## A way to mod an HV generator by TOTO4G

This is a guide to change the high voltage polarity of **AppliedKiloVolts** model HP1N.

Photo original position of component, HP1N negative HV

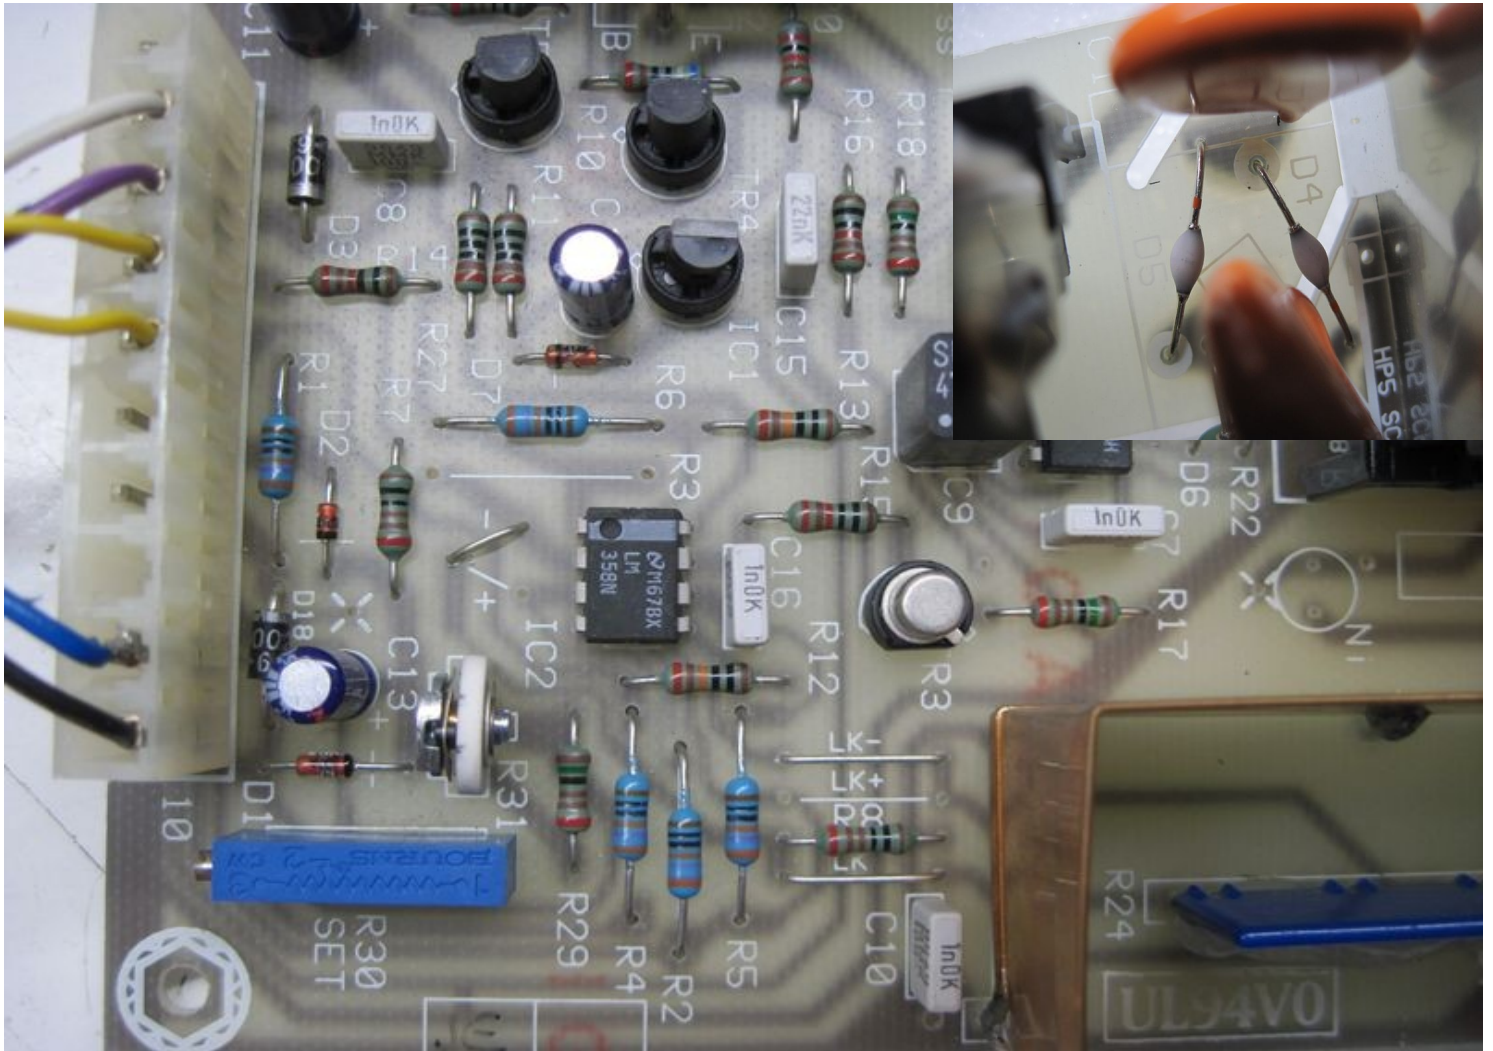
- 1) reversing the HV diodes D4 and D5
- 2) swap link - to + close IC2
- 3) swap link LK- to LK+
- 4) remove R2
- 5) put removed R2 in the R3 position
- 6) replace all the capacitors for safety
